### Proposed Revisions to a Standard Plans Index

Index Number: 521-600

Index Title: MSE Wall Coping (Precast or C-I-P)

SECTION B-B  
PRECAST COPING

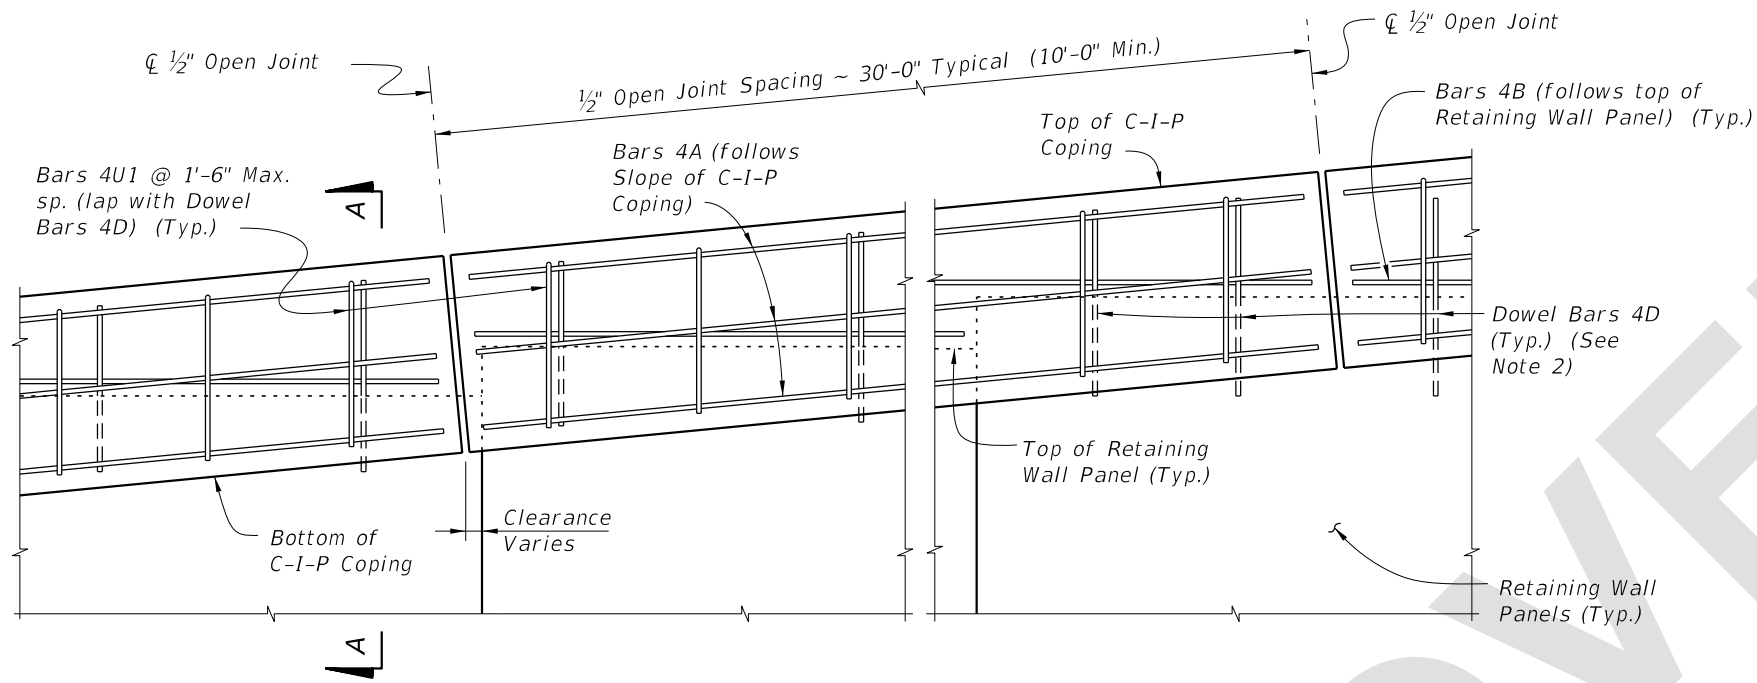
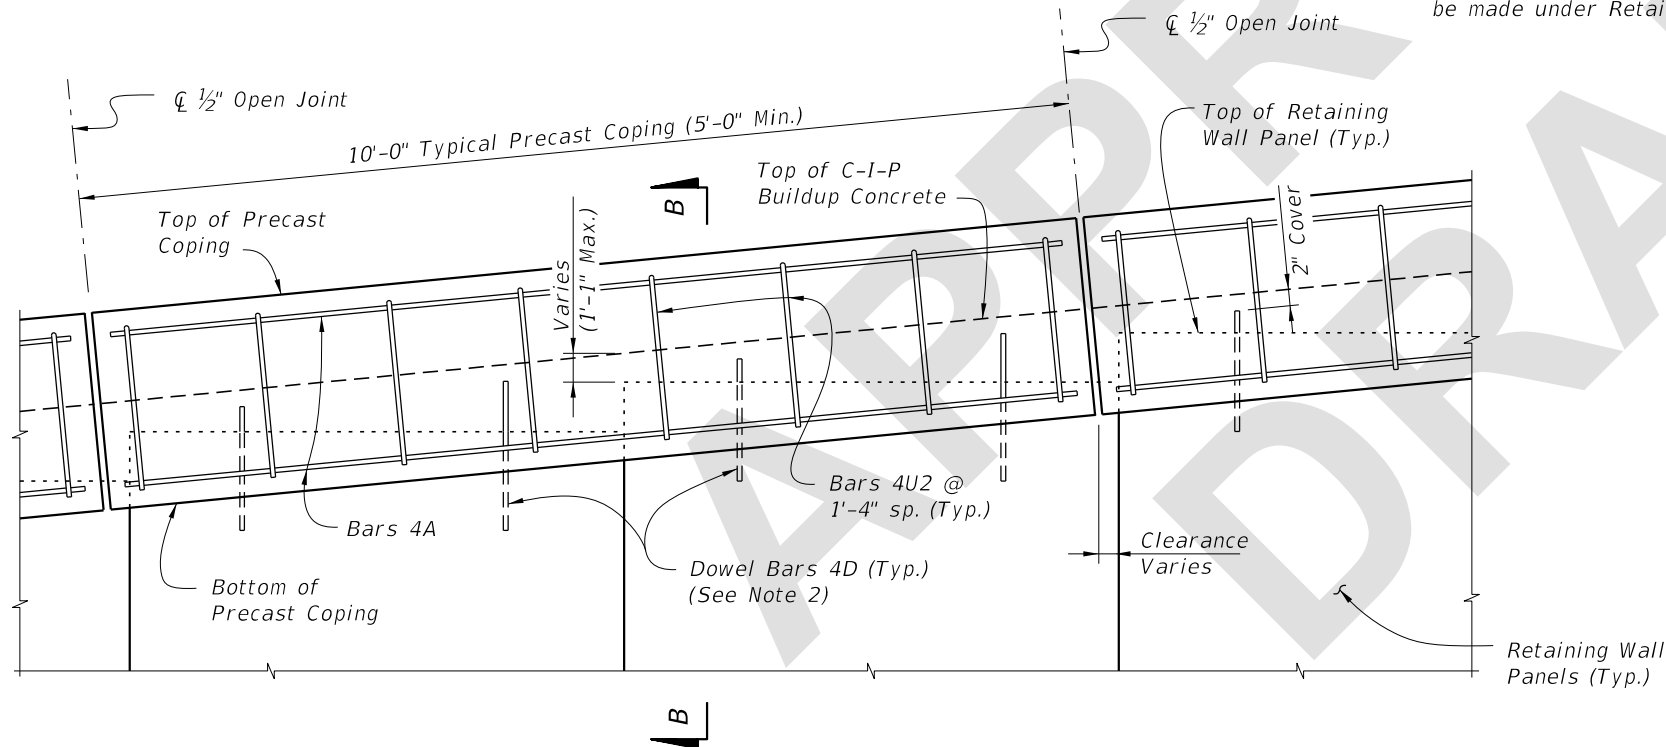
Changed C-I-P Buildup Concrete (1'-1" Max.) callout in the PRECAST COPING SECTION B-B to C-I-P Class NS Concrete (1'-1" Max.).

CHANGED TO: Class NS Concrete

CIP buildup concrete type was never clarified. SDO review deems Class NS is acceptable because the concrete buildup section is not meant to transfer any meaningful load to the wall other than self weight.
